CORRECTIONS

Fast Check for Block Shear

Paper by LEWIS B. BURGETT
(4th Quarter 1992)

Figure 2

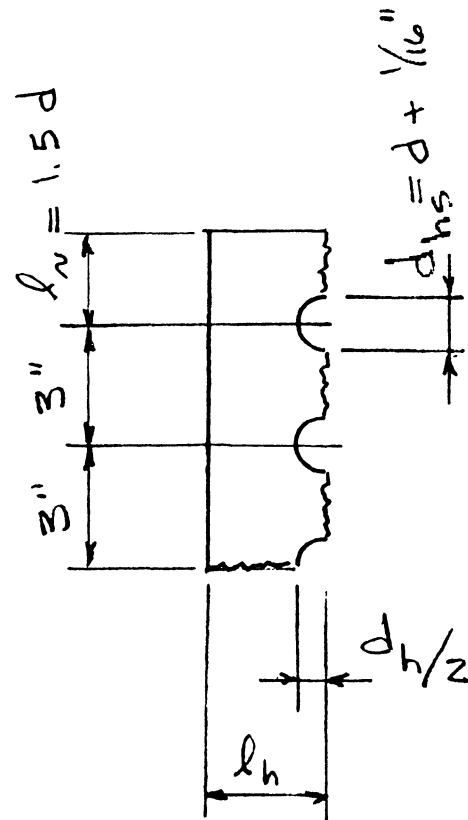
p. 126: Figure 2 should read:
